**Class II Permissive Change for
FCC ID: 2ADQJ-YSP88459SM / IC : 28512-YSP88459SM**

Model : BWR-YSP88459-SMA-LGA

Variant Difference

#. Filter change of only Bluetooth path

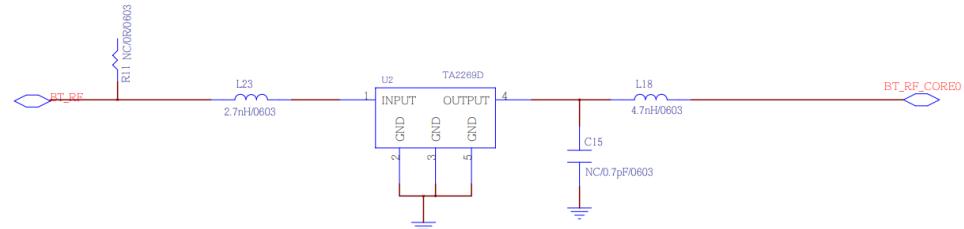
The reason for this update is the dualization of the component vendor. Consequently, a change has been implemented by amending the SAW filter within the Bluetooth pathway. new component has similar RF characteristics with previous component. All of other components are unchanged.
